To: Dr. Marcia McNutt, UNOLS Chair

From: RVTEC

Date: January 28, 2008

Appendix 1
Dr. Jon Berger's Response

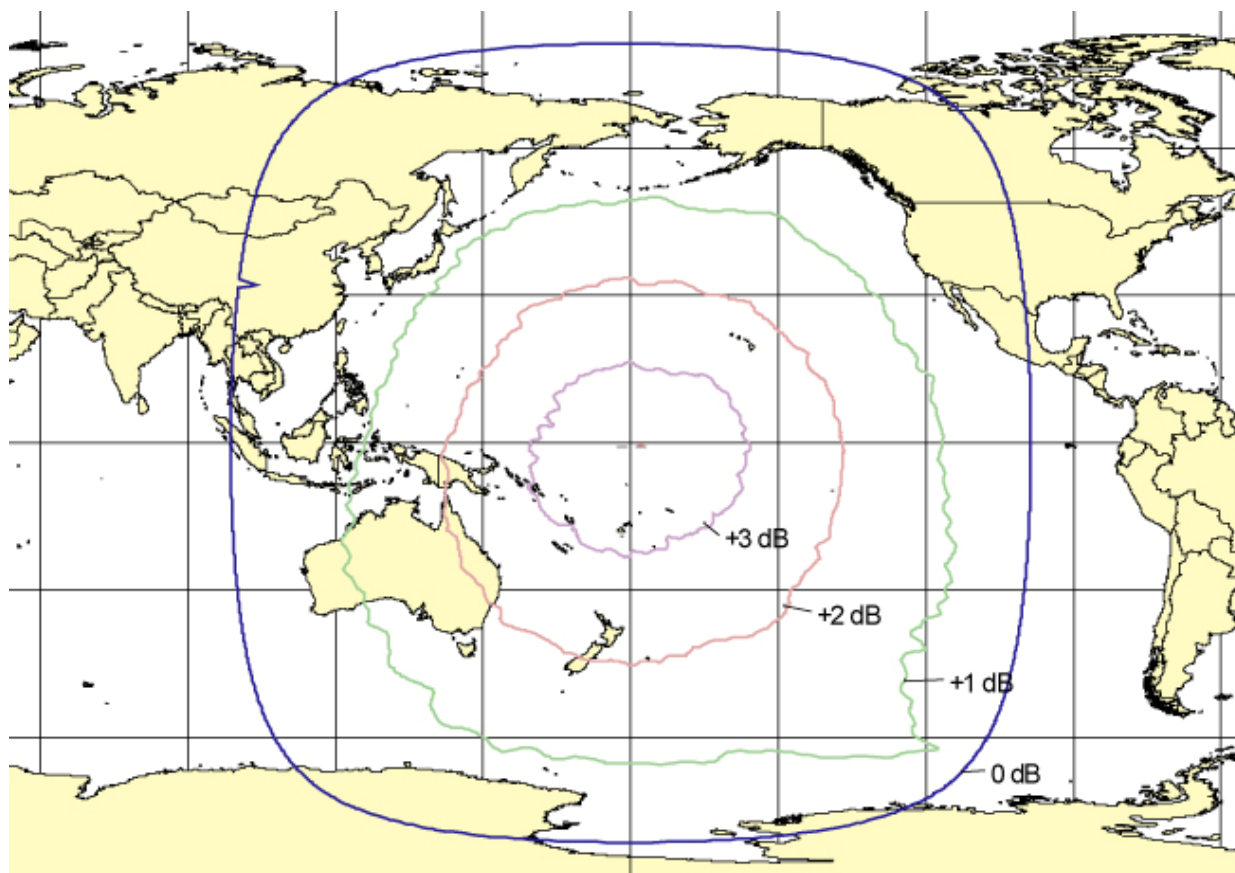
1. In order for the HiSeasNet (or any other C- or Ku- band satellite) communications system to work there must be an unobstructed line of sight between the ship's antenna and the satellite transceiving its signal. The azimuth and elevation angles of this line of sight depend on the relative locations of the ship and satellite. For example, the satellite we use in the Pacific is located above the equator at 180 degrees longitude. When the ship is near these coordinates the antenna points approximately straight up and no shadowing should take place. However as the ship approaches the edges of the beam (see blue line in the figure below) the elevation angle gets lower and lower (0 degrees for the blue line) and hence shadowing may occur due to blockage of parts of the ship's superstructure or appendages.

2. There are two ways to alleviate this shadowing; one is to elevate the antenna above all superstructure and appendages. (See for example the installation on the NOAA R/V Ron Brown below)

The second way, favored by the Cruise ship industry, is to install redundant antennas so that when one is blocked the other is not. Neither of these methods are particularly attractive for the UNOLS fleet but I believe each ship might be able to improve performance by judicious re-location of the existing antenna.
